STAFF REPORT
KETCHUM PLANNING AND ZONING COMMISSION
MEETING OF SEPTEMBER 9, 2025

PROJECT: Warm Springs Townhomes

FILE NUMBER: P24-063

APPLICATION: Design Review

2 1/4" = 1'-0" BUILDING 4 / ELEVATION - WEST

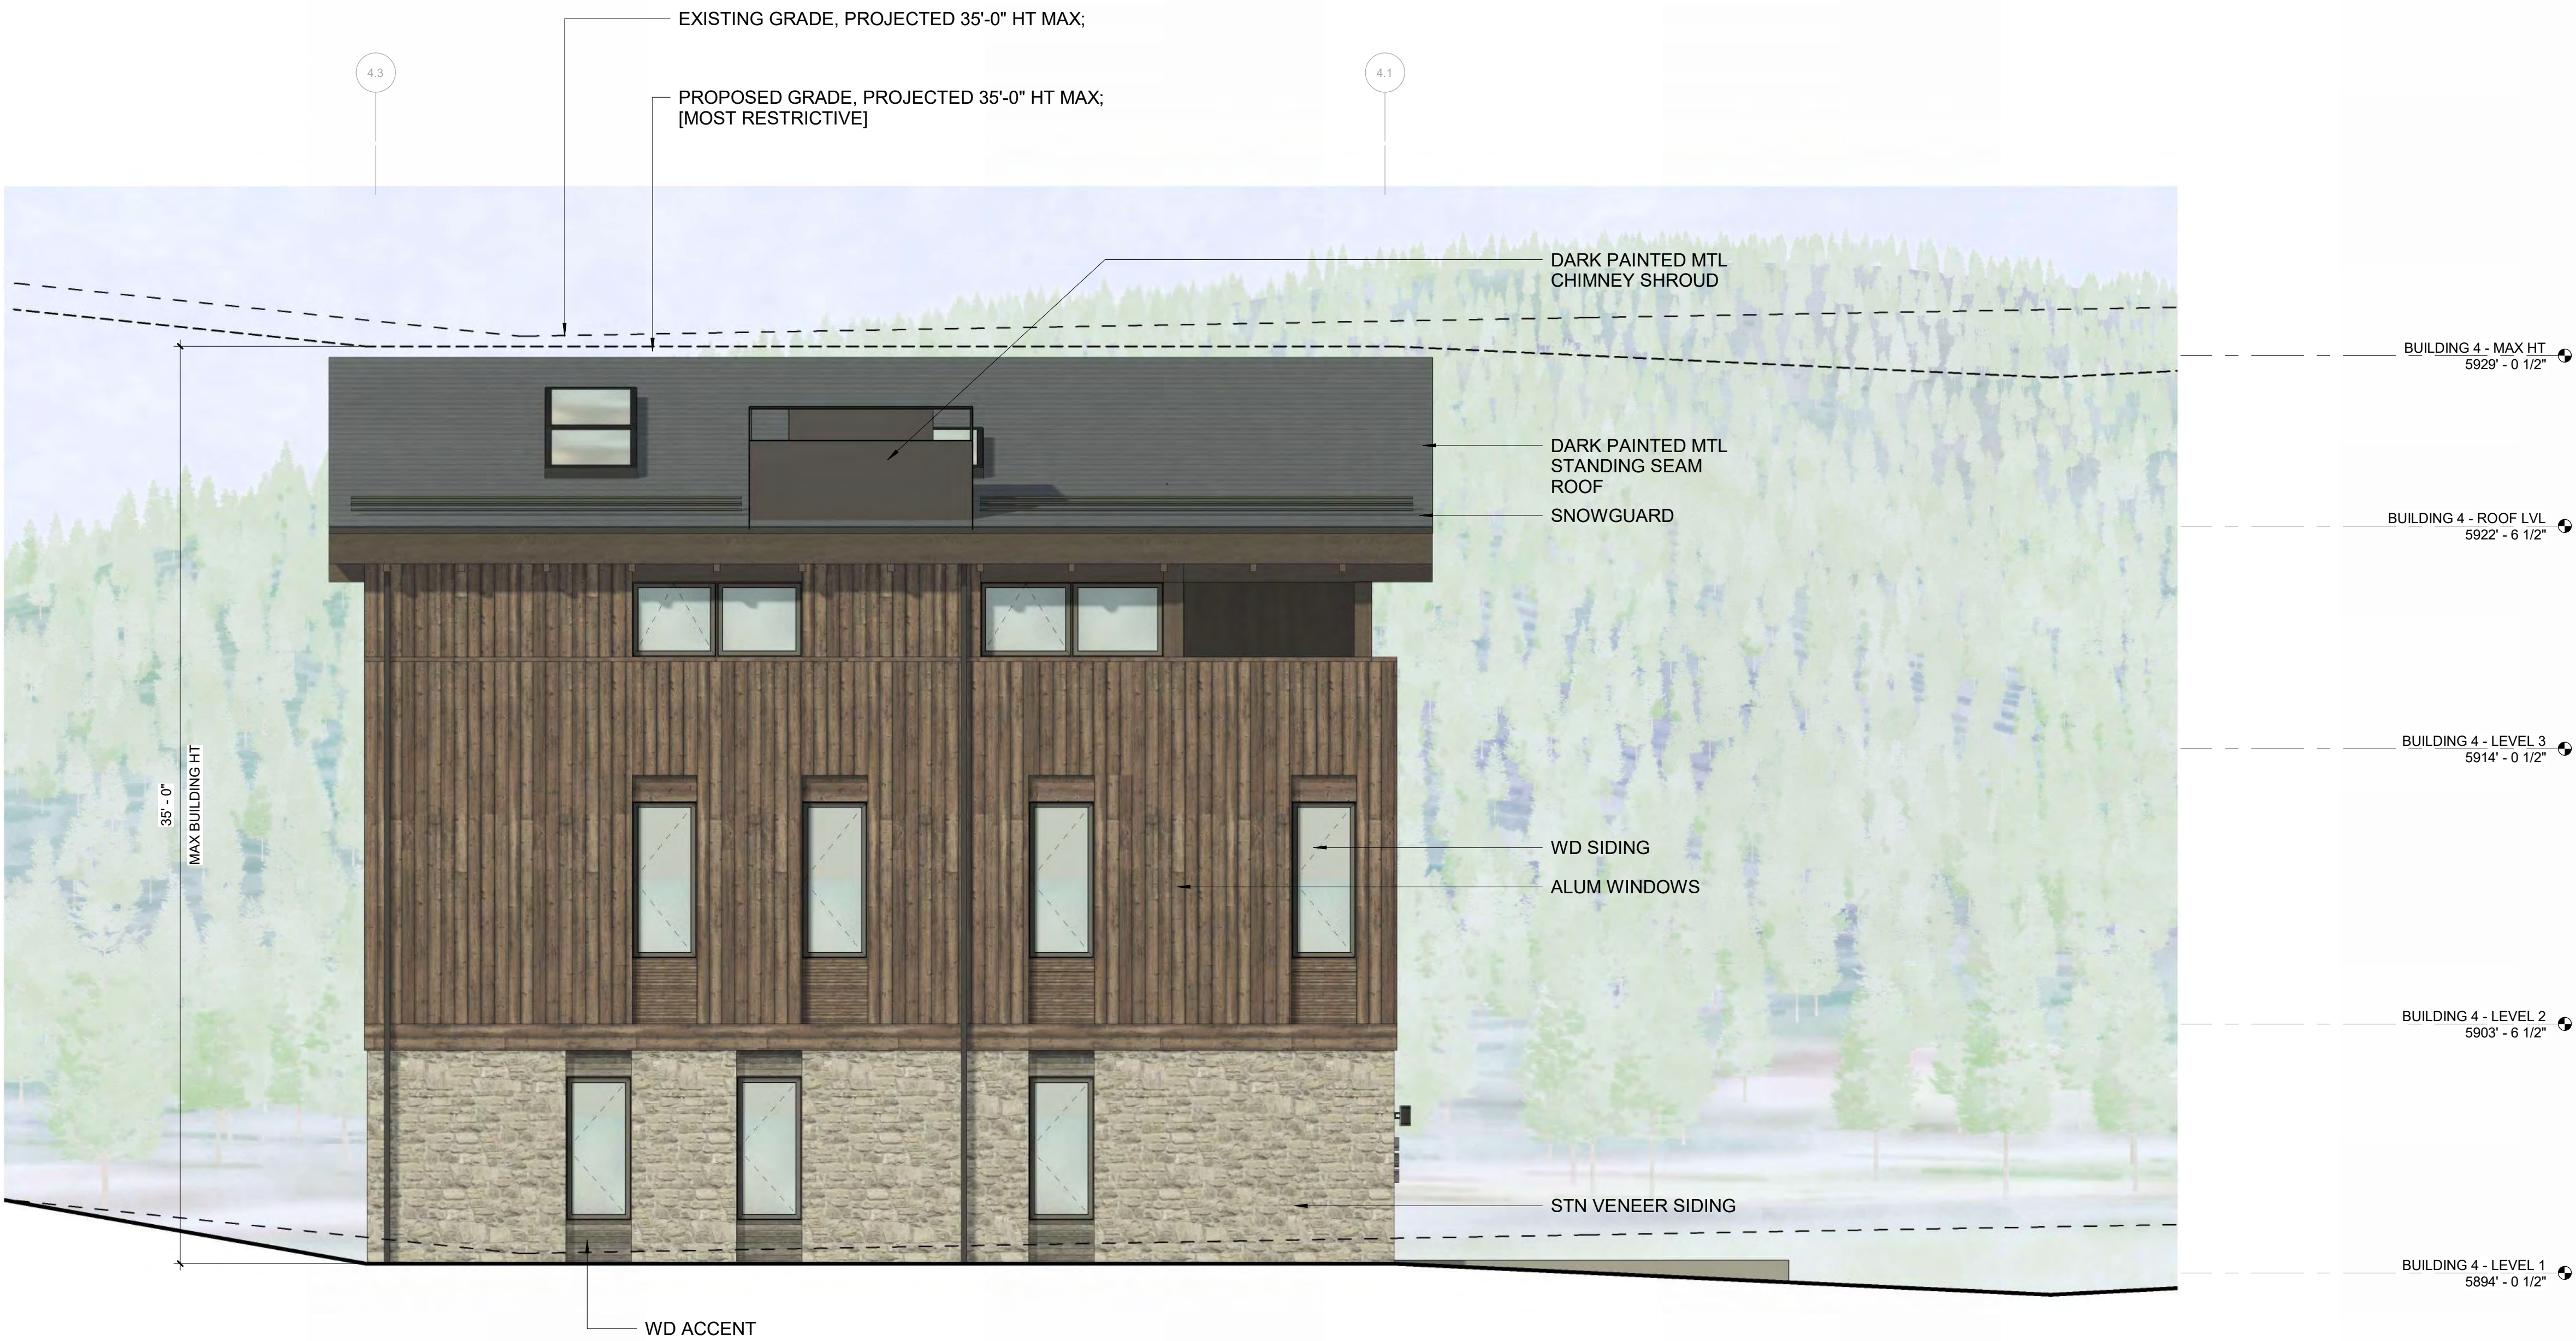
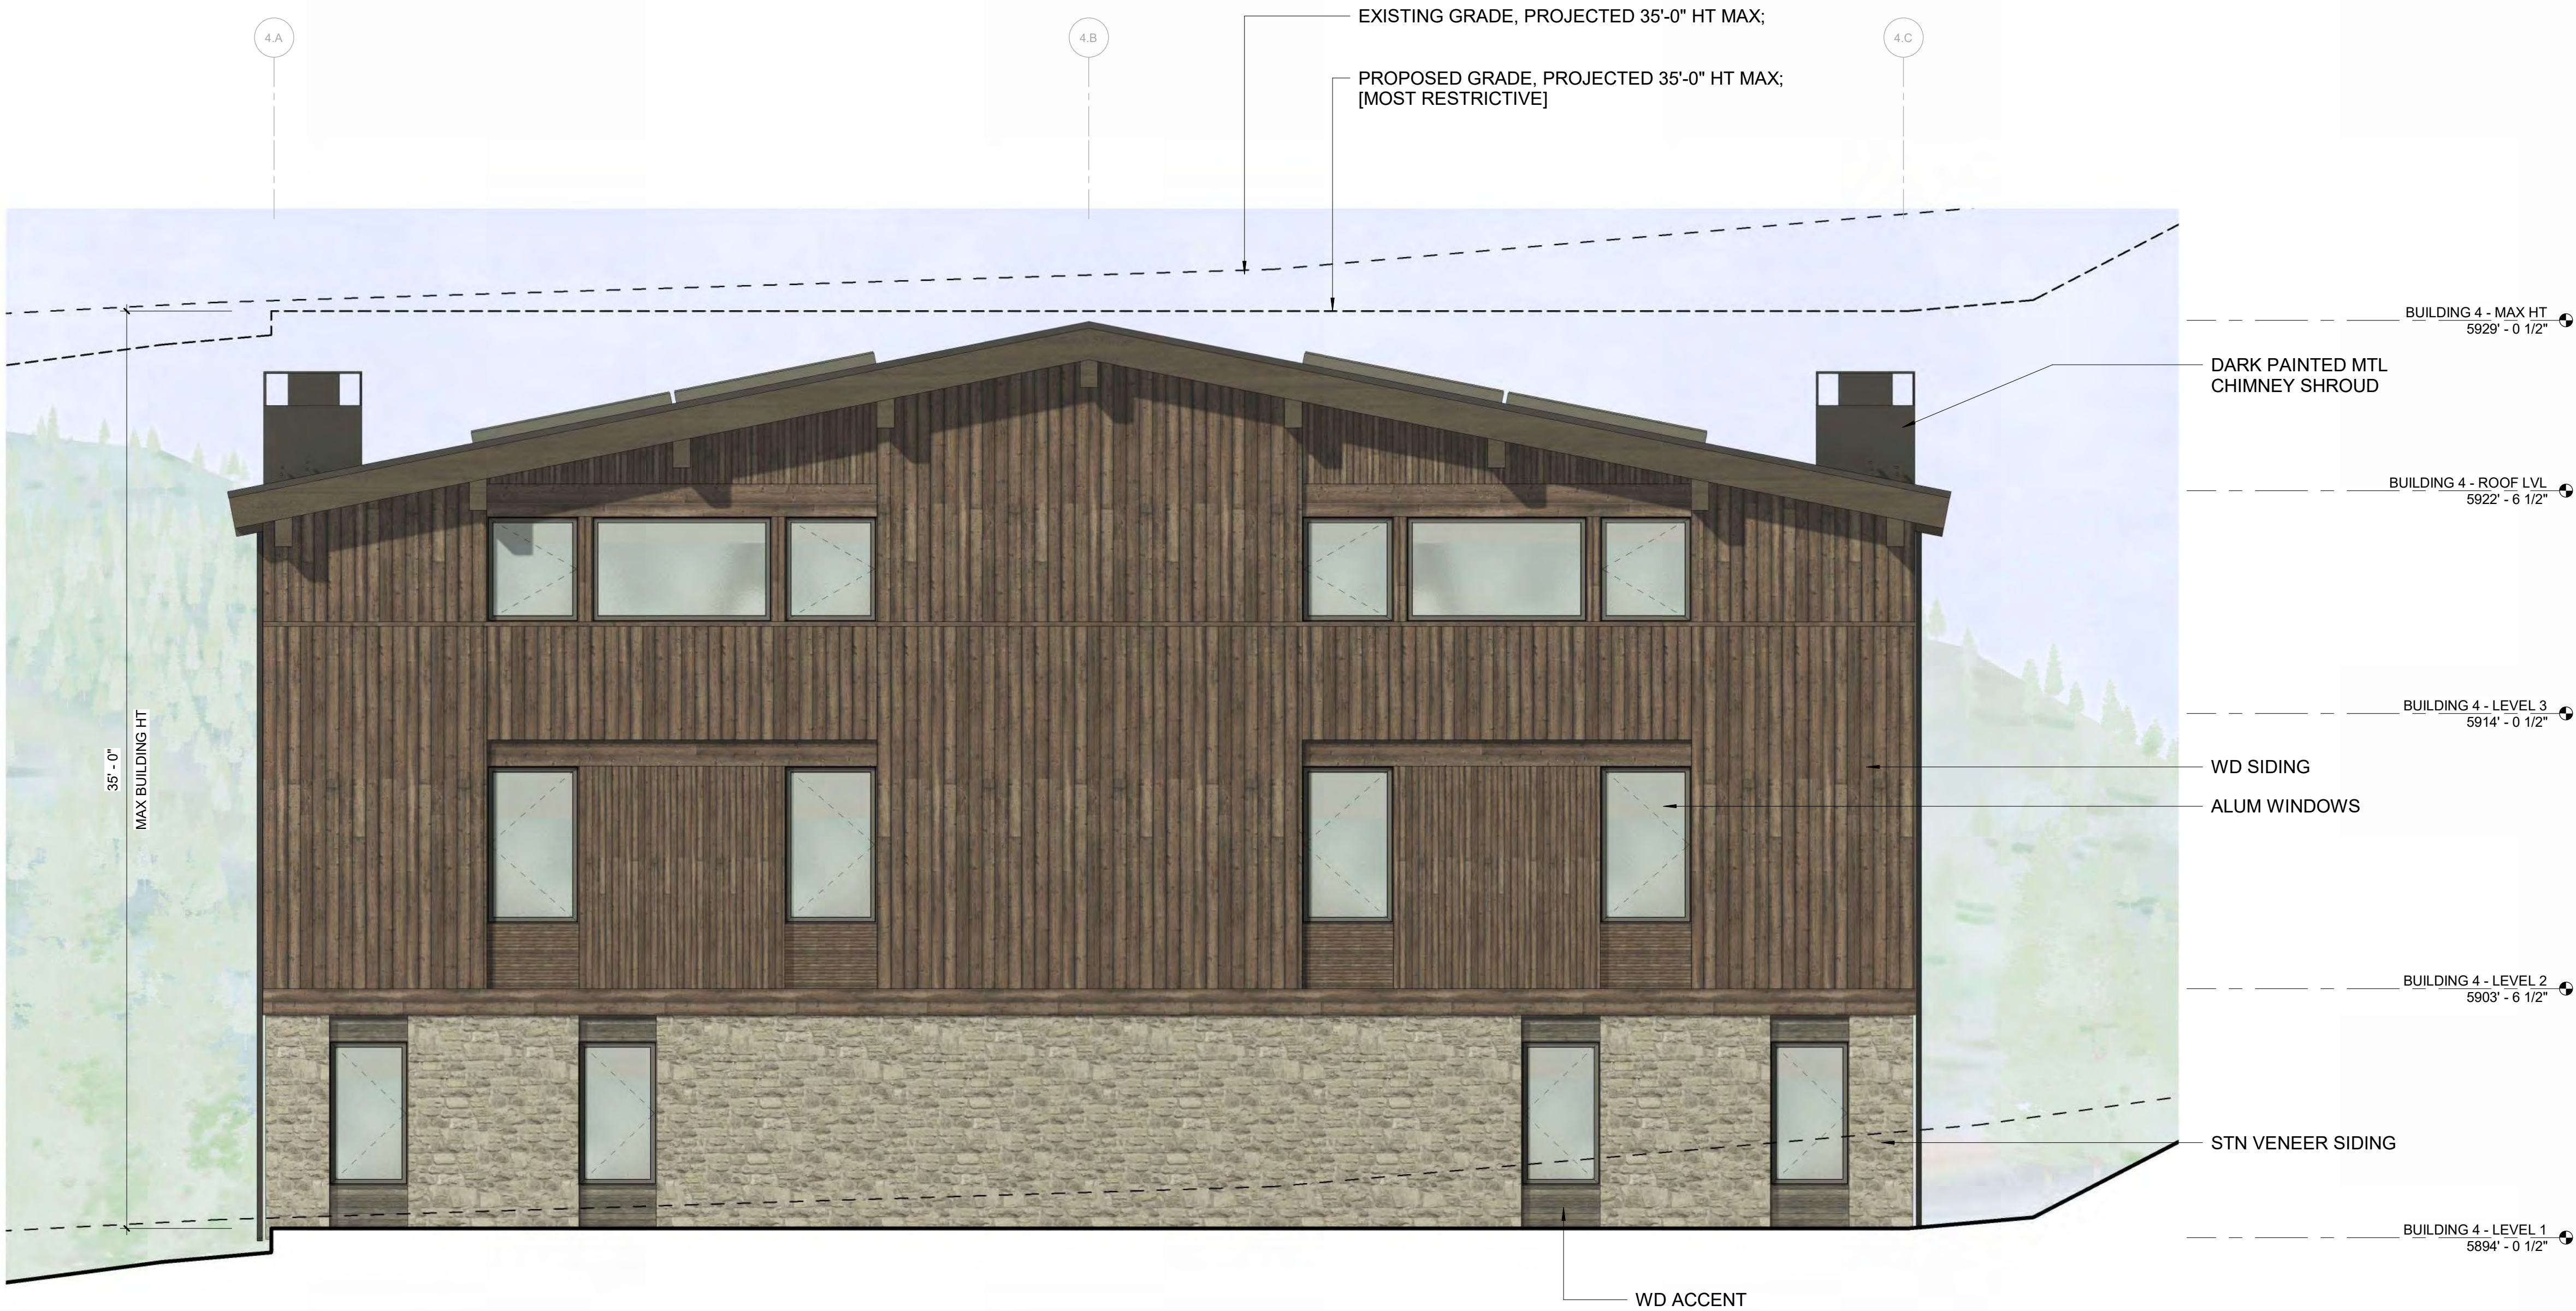
Staff believe these facades to be quite flat and lack architectural features that provide interest and relief from the flat appearance of the structures. It is clear the applicant is drawing inspiration from historic mining structures that often feature tall narrow windows in a repetitive pattern. However, the recessed nature of the windows with minimal trim contributes to the flat nature of the elevations. Staff believe the addition of some key architectural features could assist in adding interest to these elevations. Additionally, the Commission commented on the front façade of Building 3 (see Figures 7 and 8) noting that interior buildings should have similar consideration as the others. Staff agrees that continuity throughout the development is critical and also understands the varying degree of architectural detailing between interior and exterior facing facades. Some considerations for Building 3 may be the reduction of the roof overhang so it is no longer flush with the first and second levels of the building. The applicant could also consider some window trim options to add interest to the facades.

17.96.060.F.5 – Architectural	Conformance
<i>Building walls shall provide undulation/relief, thus reducing the appearance of bulk and flatness.</i>	NO
<p>Finding: There are four buildings within the proposed development, each one with certain aspects of the building visible from public vantage points. Elevations of the buildings are included in Sheets A-300 through A-306. Perspectives from the street are provided on Sheets A-500 through A-505. Buildings 1 and 2 front Ritchie Dr. These elevations have pitched roofs with modest overhangs that do not extend past the cantilevered decks below. The roof detailing also includes exposed beams which is a common architectural feature in the area that softens any sharpness created by the roof overhang. The cantilevered decks, although repetitive along the façade, occur at a separation that accentuates the individual units. The glazing of the second floor is appropriate for the scale of the façade. There are recessions on the ground floor for entrances which also create interest at the street level.</p> <p>However, the side elevations of all 4 buildings and the front elevations of Buildings 3 and 4 lack undulation and relief. See the staff report for further discussion.</p>
